Missouri Department of Natural Resources
Air Pollution Control Program
2016 Monitoring Network Plan

November 15, 2016

**APPENDIX 6: COMMENTS AND RESPONSES ON PROPOSED 2016 MONITORING
NETWORK PLAN, REVISION 0**

**APPENDIX 7: COMMENTS AND RESPONSES ON PROPOSED 2016 MONITORING
NETWORK PLAN, REVISION 1**

Figure 10. Wind rose for Ameren’s Valley met station showing the five highest frequency wind sectors and the percent of hourly winds each sector contains.

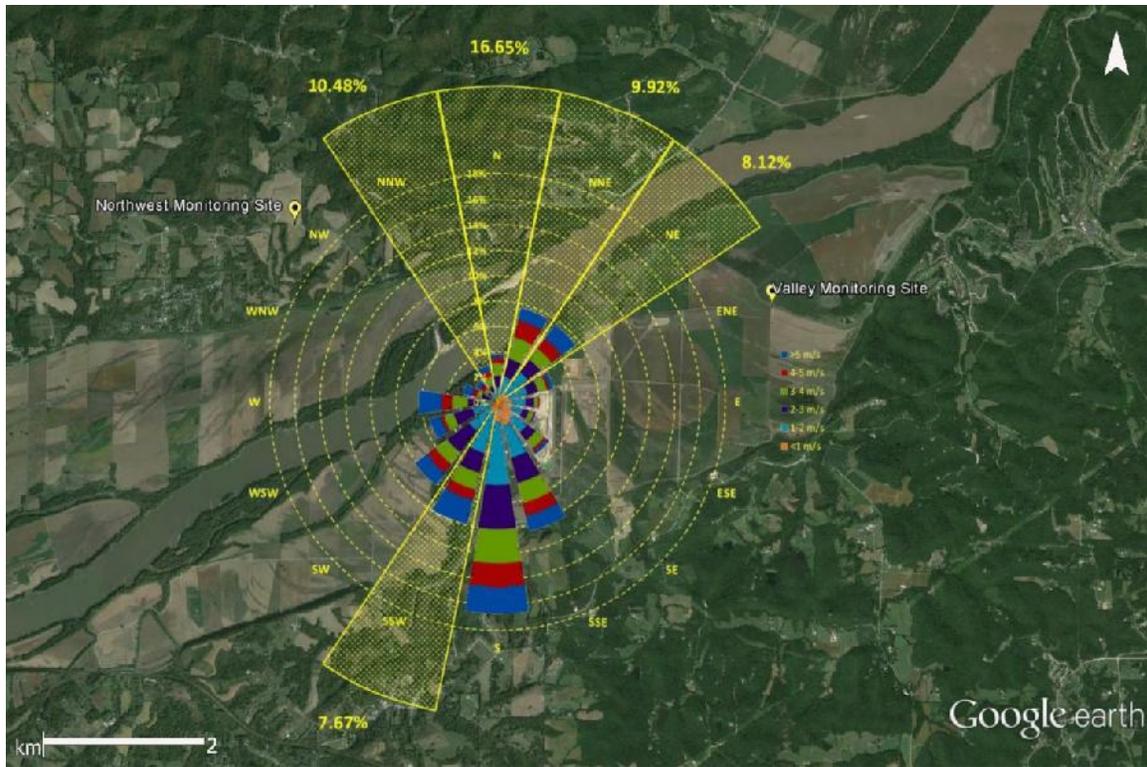
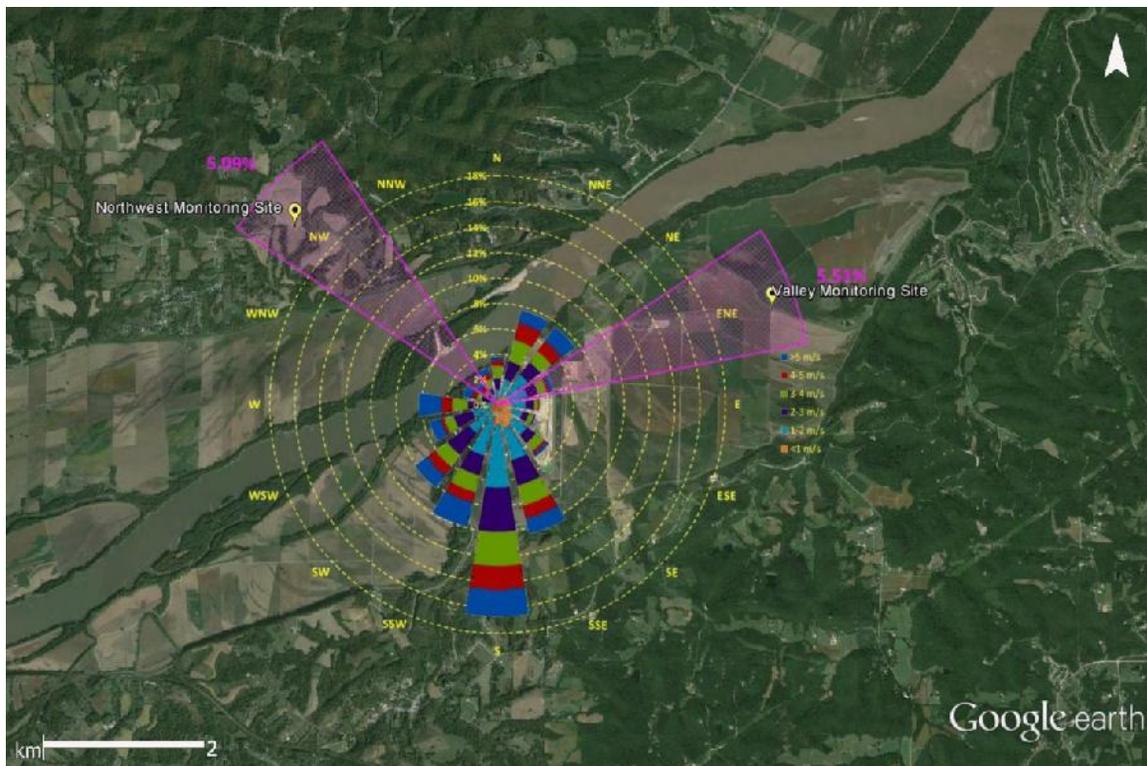
The wind rose for Ameren’s Valley met station shows a similar pattern. This wind rose and the five peak wind frequency sectors for it are shown in Figure 10, below. The peak wind frequency sectors (N, NNE, NE, SSW, and NNW) are the same as the peak wind frequency sectors for the historical on-site meteorological tower and the recent WRF modeling with one exception—the the SSW sector replaces the E sector—and they collectively contain over 50 percent of all hourly winds but do not include either of the monitors. The same wind rose and the wind frequency sectors that do include the monitors are shown in Figure 11, below. The two sectors that include the monitors each contain closer to 5 percent of all hourly winds.
